在新界大埔十四鄉丈量約份 209 約第 281 S.E.RP、
299 RP 及 301 RP 號
申請臨時私人停車場(只限私家車)
申請編號: A/NE-SSH/157

Layout Plan

Lot 281 S.E RP , 299 RP , 301 RP in DD209, Sai Keng, Sai Kung, NT

FIGURE 5

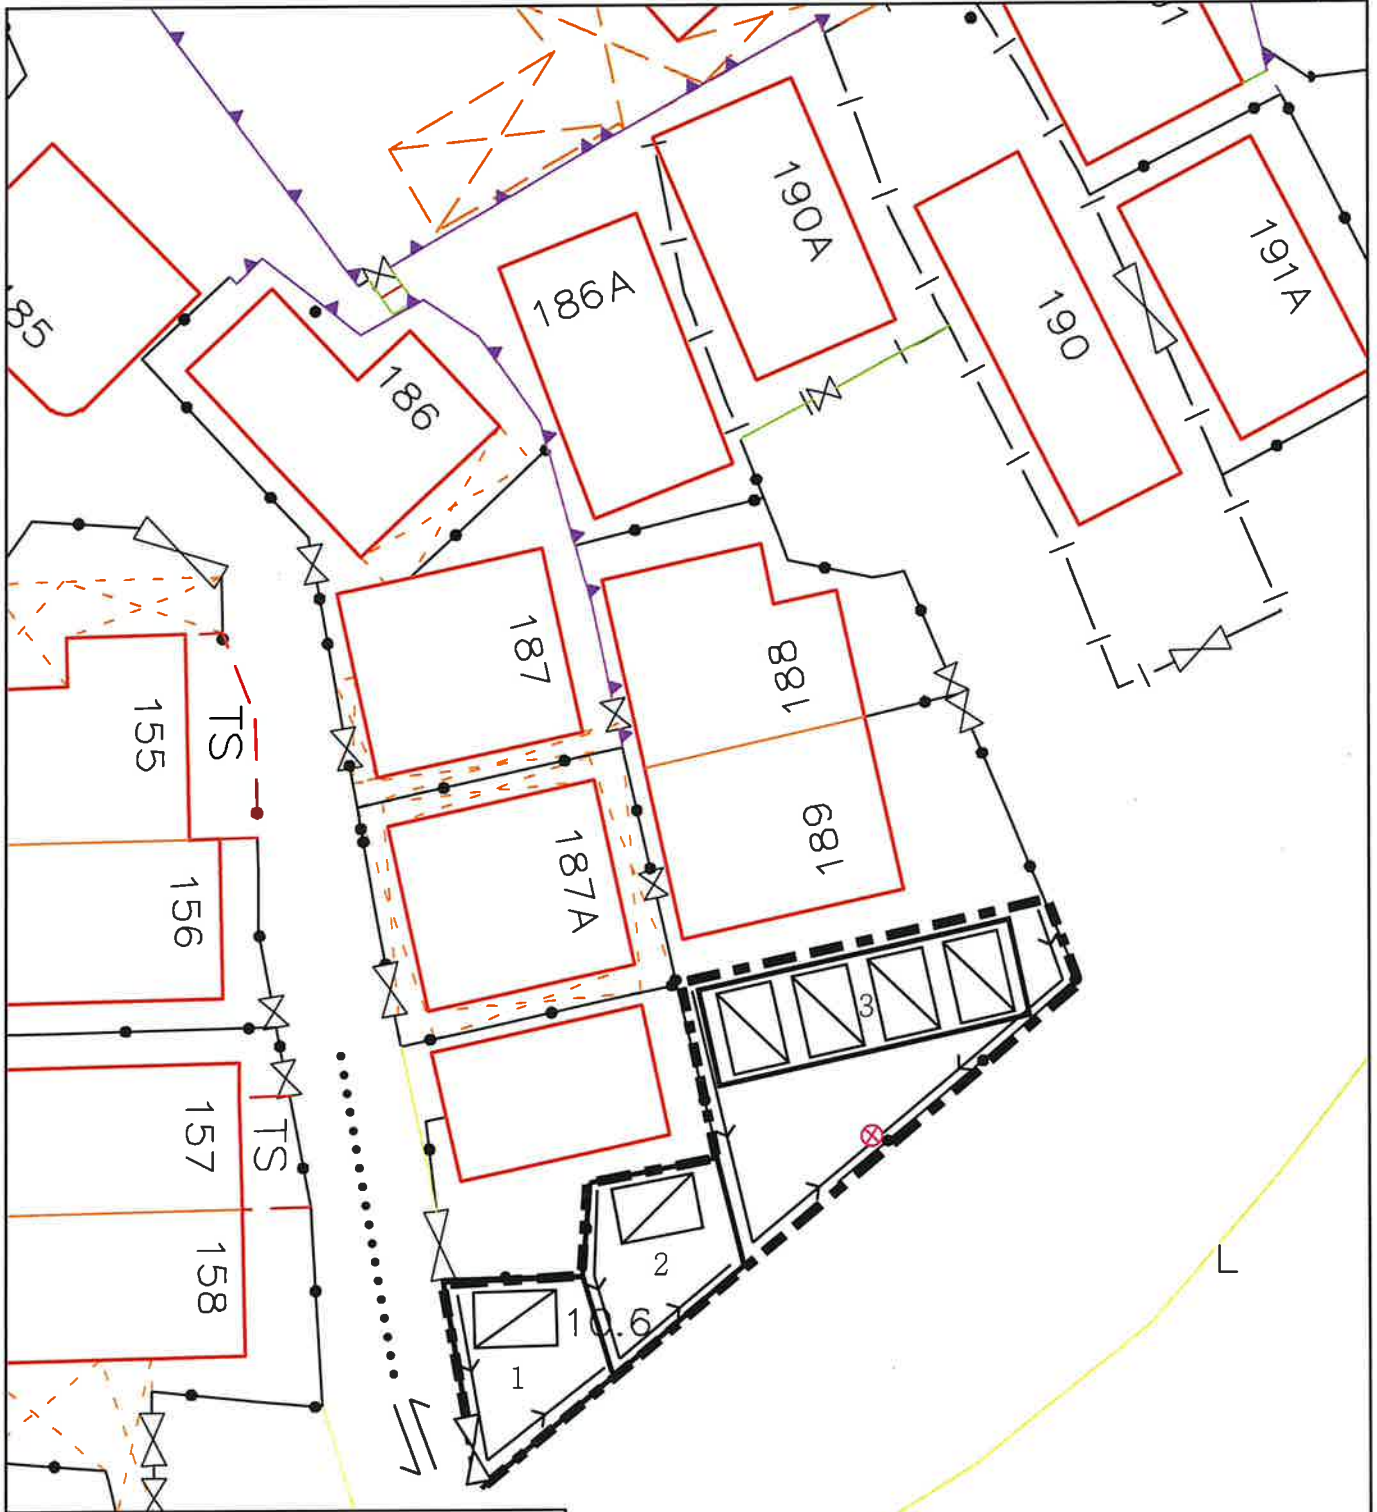
本人 是標題地段的授權人。得到 貴處於 30.5.2024 通知測繪處的
提示, 已將地段第 299 RP 號的面積修改為 36.5 sq.m(見附圖 1);

同時, 渠務處對這申請個案亦有要求, 現擬議在上述地段周邊做兩
水渠流向現有的雨水收集點(見附圖 2); 建築工程人員會按地形升高少許, 配合
所有雨水都能順暢流向收集點, 接駁到村內的公共去水渠, 絕不會影響其它私人
土地產生積水。
